Re. Sub-division of plot No. 2, K-17,
Lyari Quarter.

PLAN OF EXISTING BUILDING SHOWING PROPOSED
SUB-DIVISION ON PLOT No 5 SHEET RB-7 RAMBAUGH & R
Scale 8" = 1"

PLAN
SHOWING PROPOSED BUNGALOW
ON PLOT NO 21 SHEET NO J-M-1.
JANGHED QUARTER.
SCALE 3"=1."

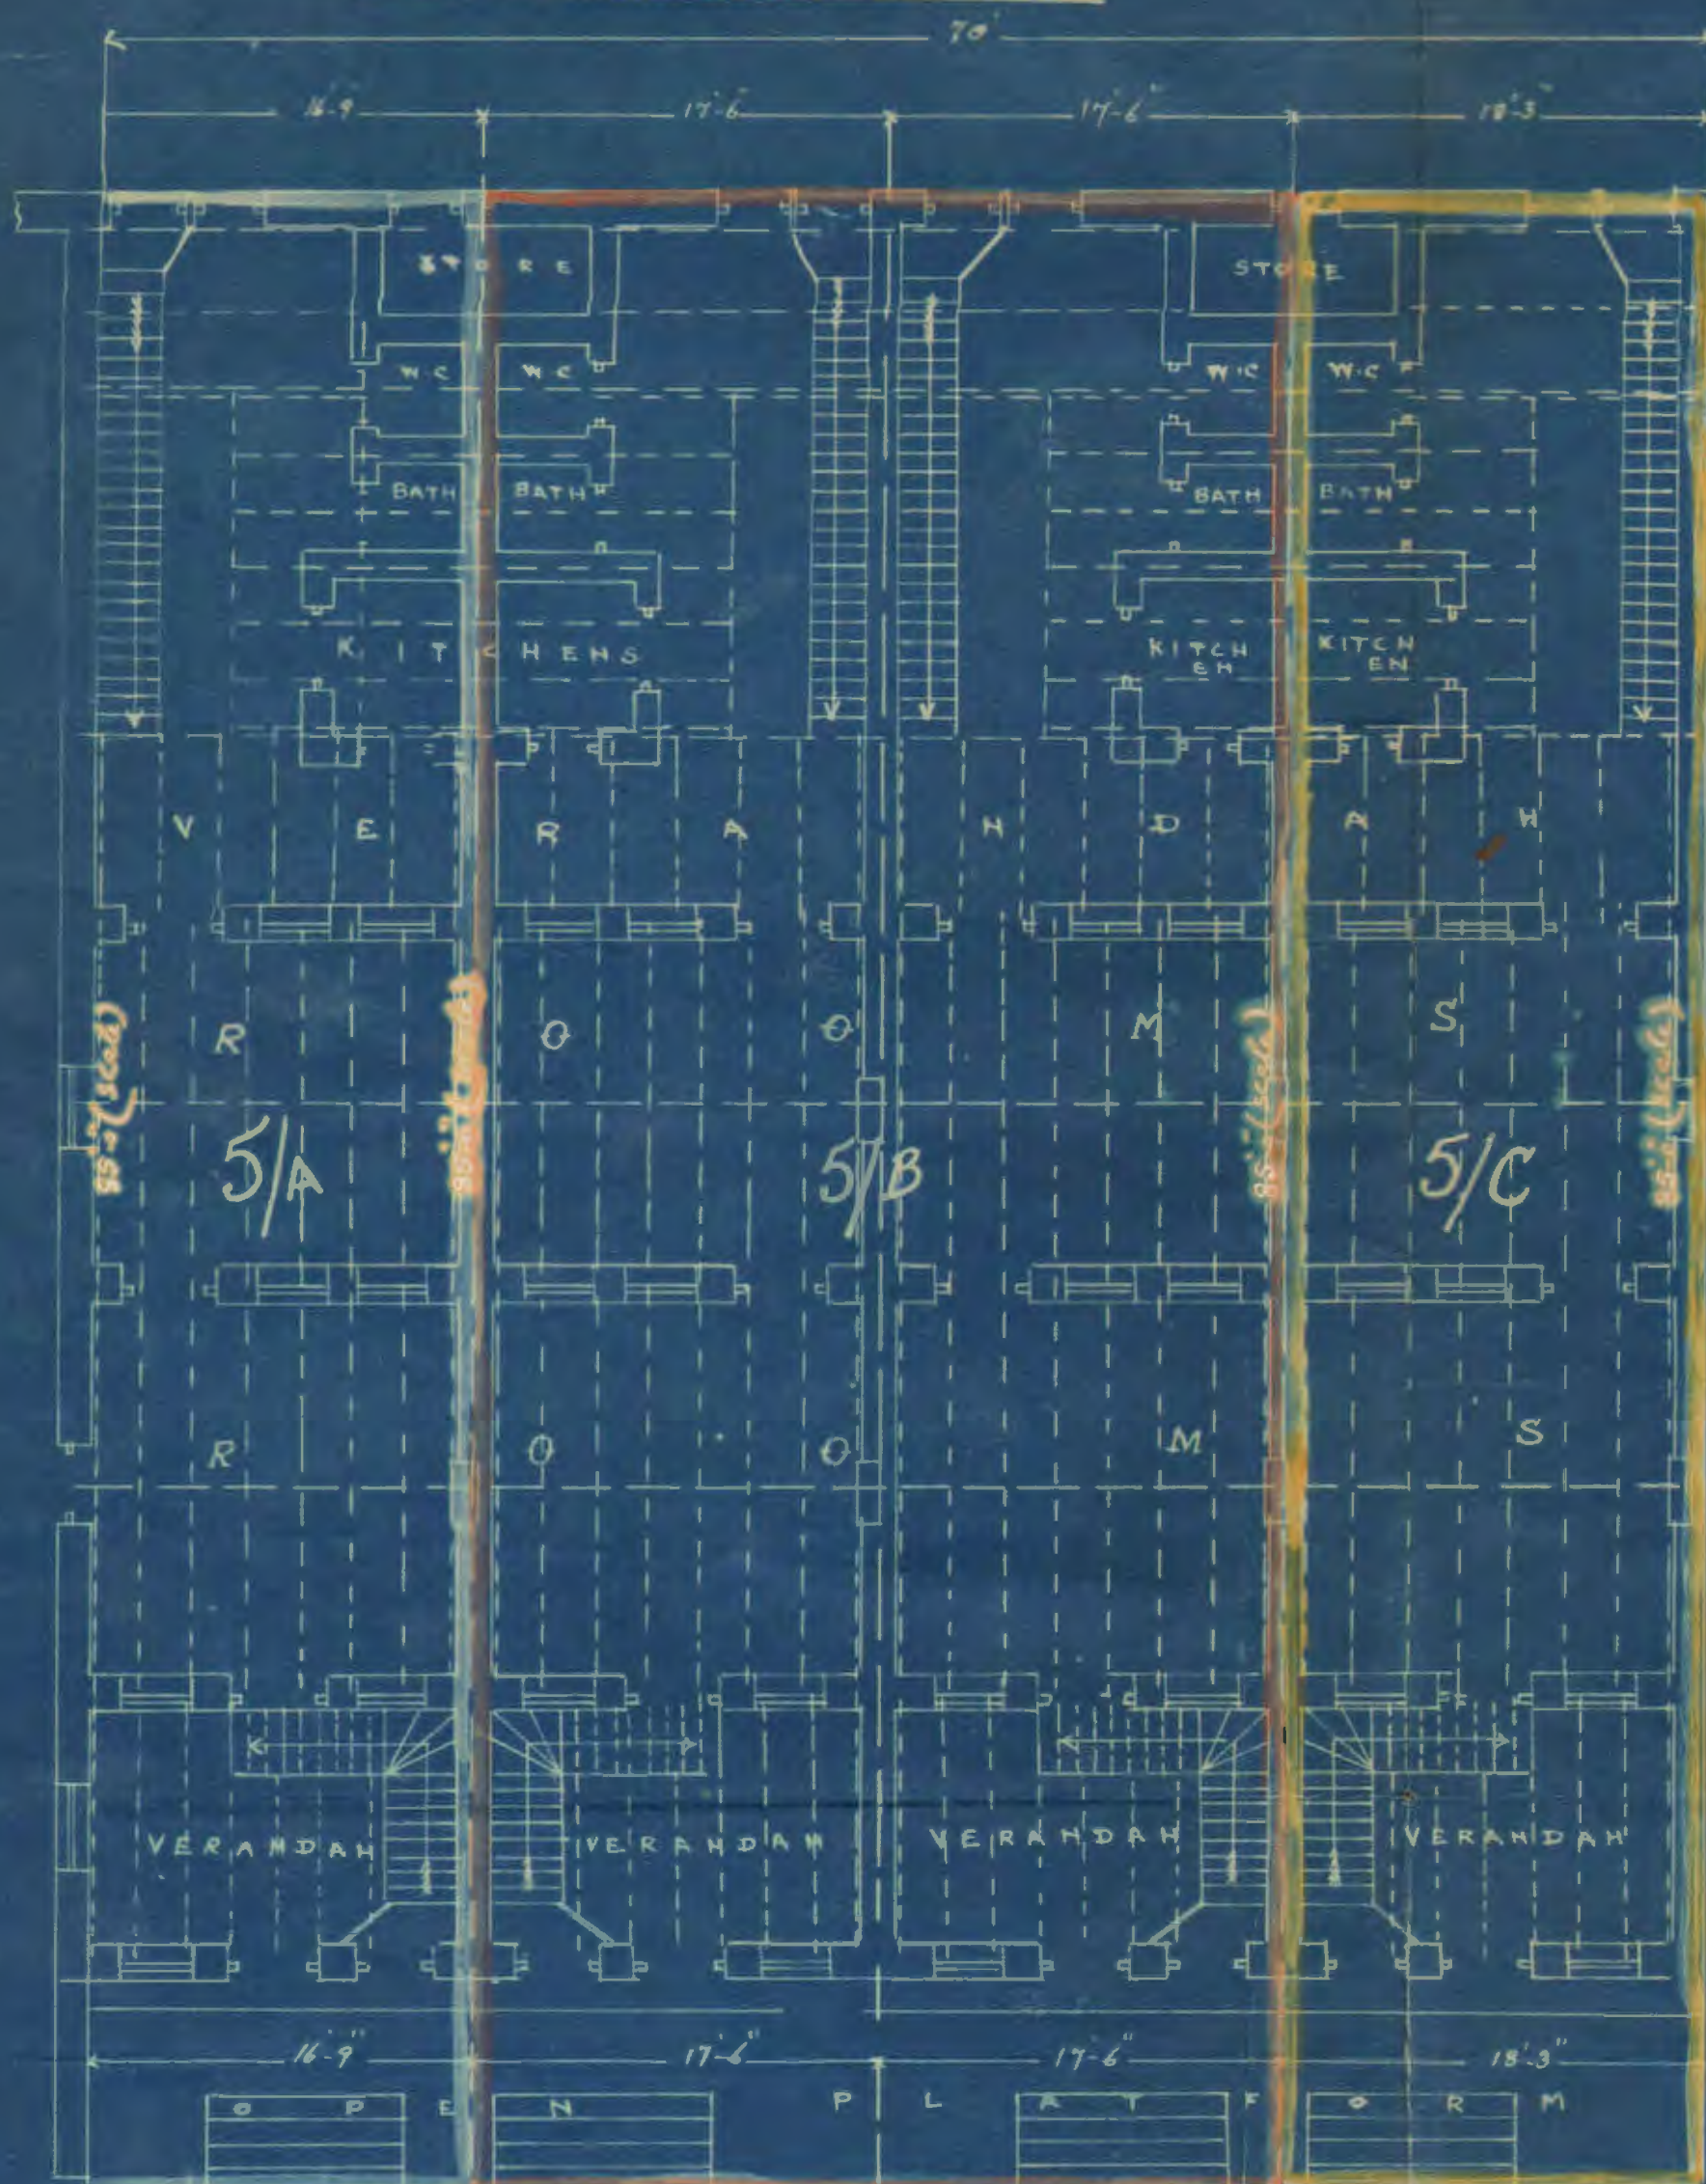
With reference to your letter No. R.B.7/5 dated 23-2-33 re- above, I have the honour to inform you that the subdivision plan sent by you requires to be corrected as per additions and alterations passed by the Municipality, *when the same can be further considered.*

There are only three subdivisions
and not four. The central f. case
has one combined per. $\frac{6}{9/5}$

PLAN OF EXISTING BUILDING SHOWING PROPOSED
SUB-DIVISION ON PLOT No 5 SHEET RB-7 RAMBAUGH QR
Scale 8' = 1"

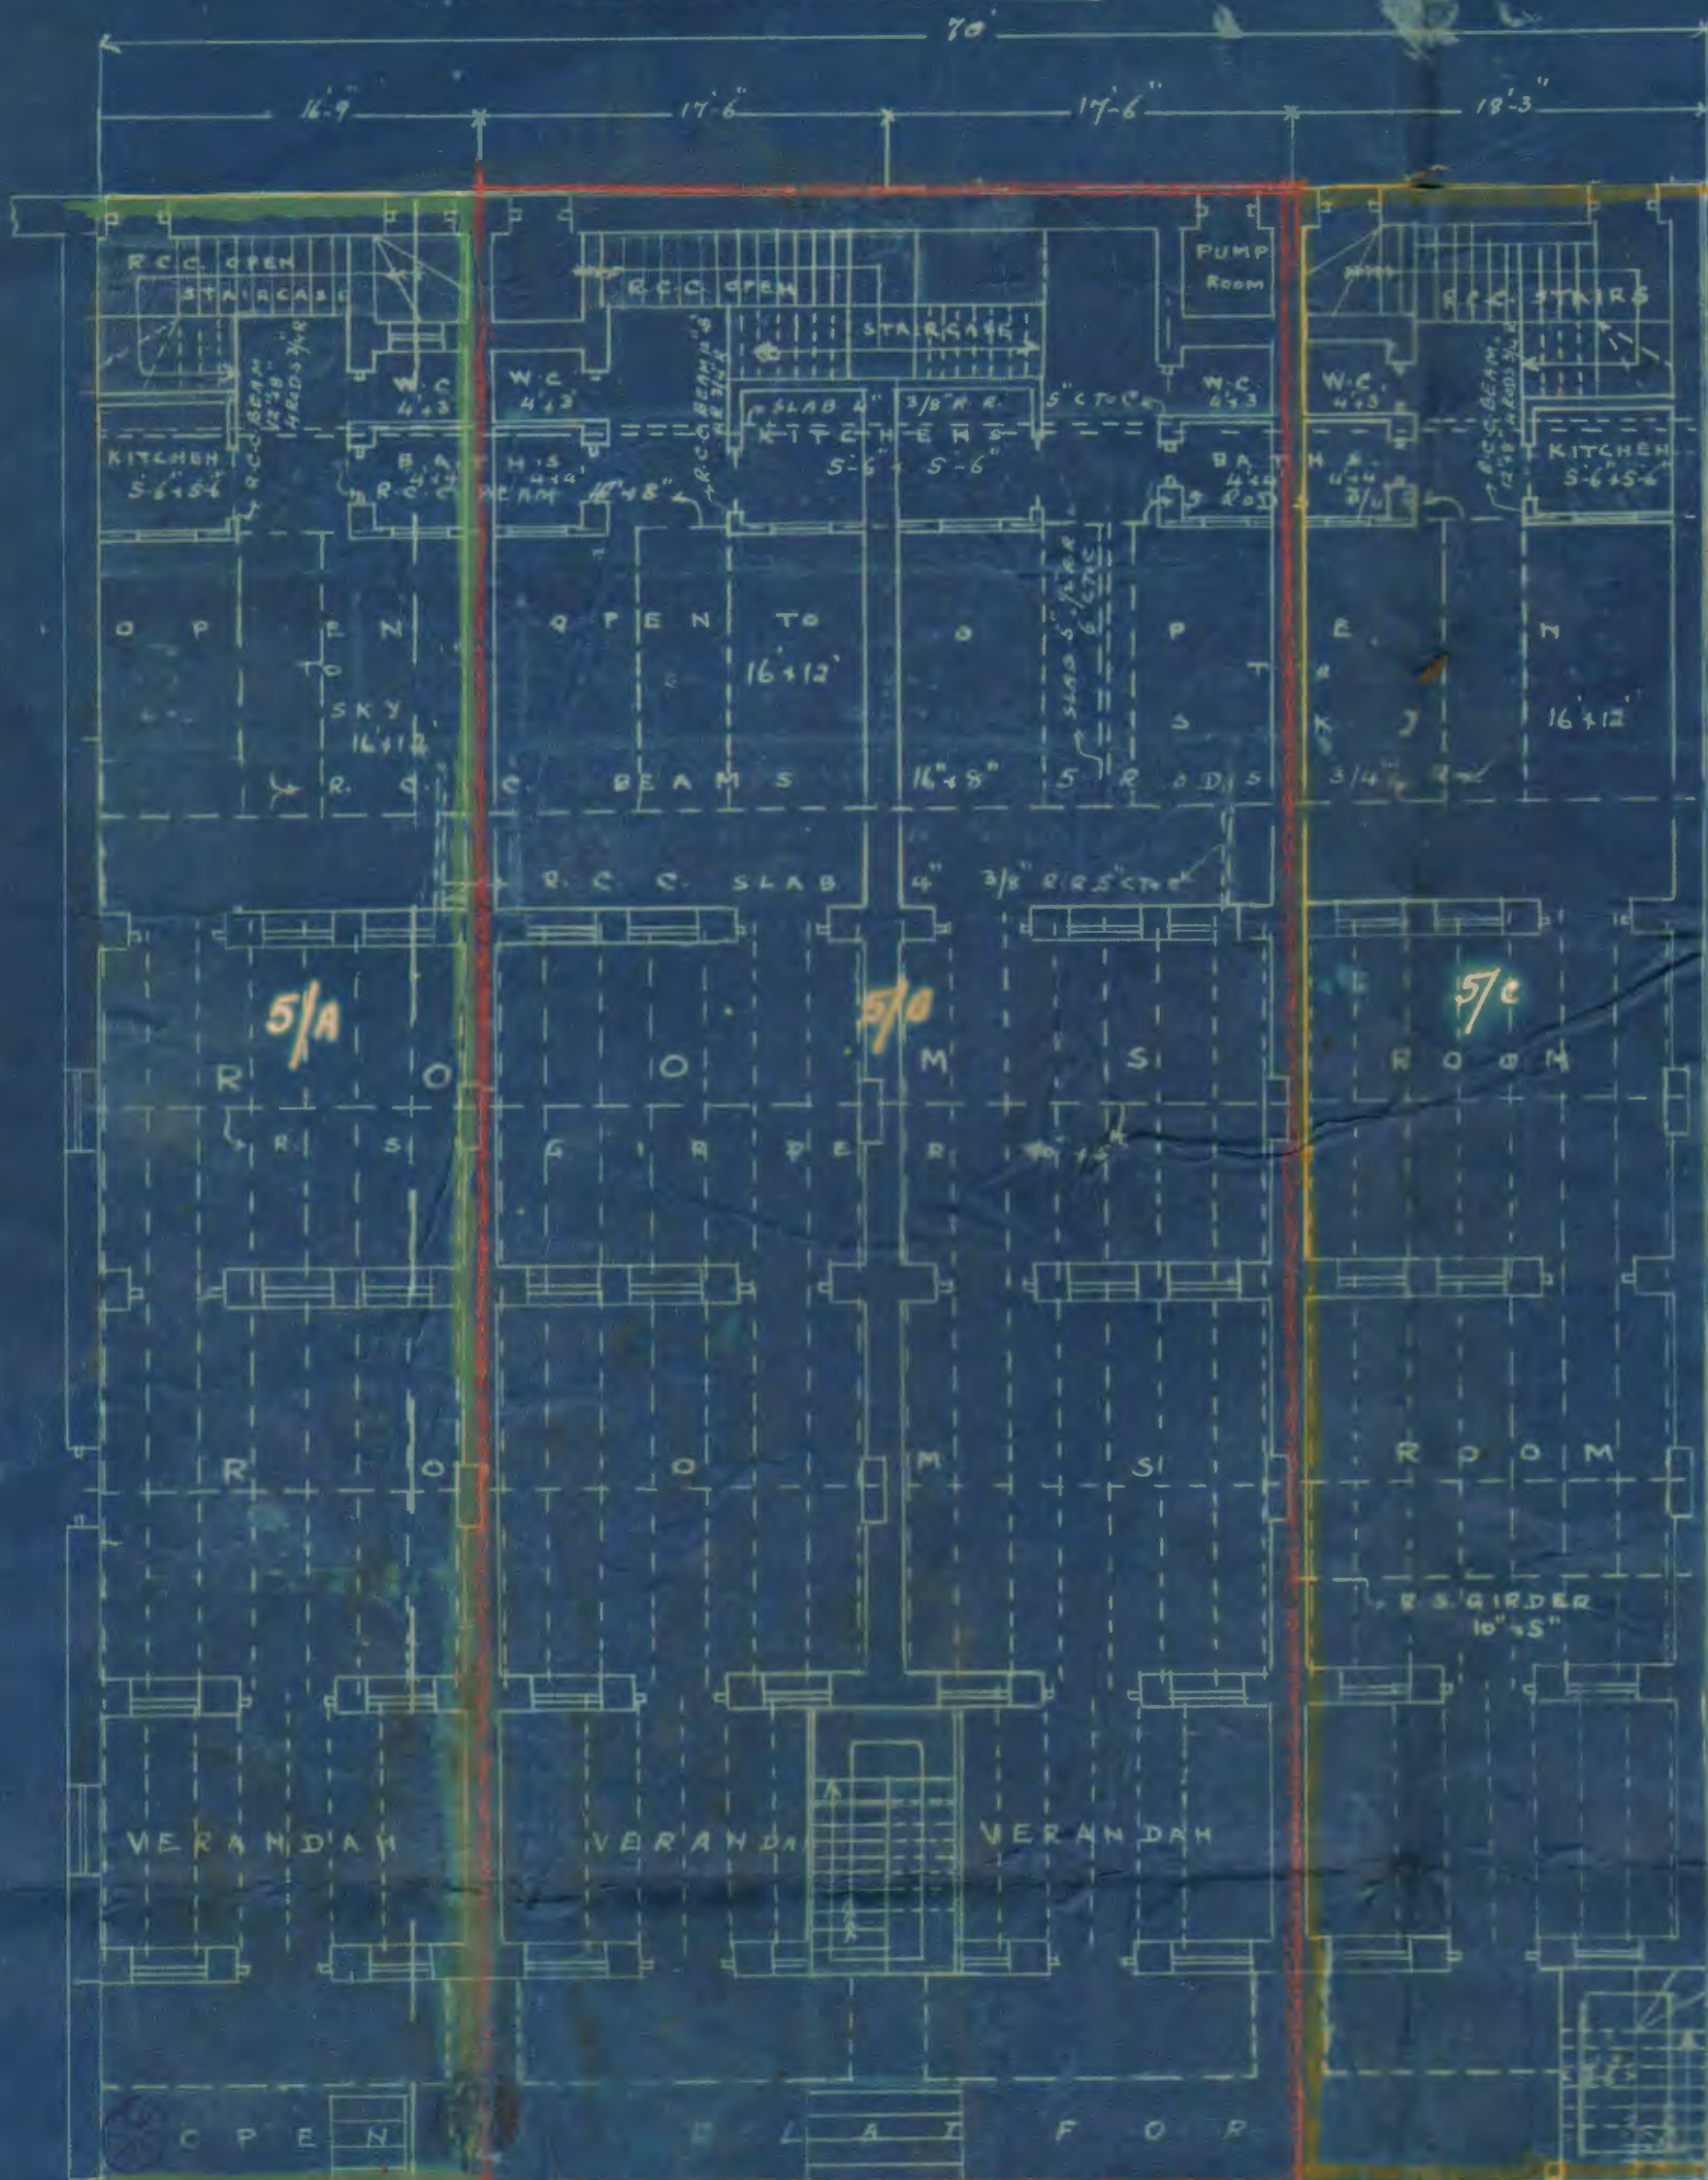
The wall on the North is shown as belonging
to the Neighbour the owner also,

With reference to your endorsement No. R.B.7/5, dated 26th April 1933, I have the honour to inform you that plot marked 5A on plan No. 16 (copy attached) has got no wall of its own on northern side and under the circumstances the sub-divisions cannot be allowed.

The plans have been
corrected $\frac{2}{12/5/33}$
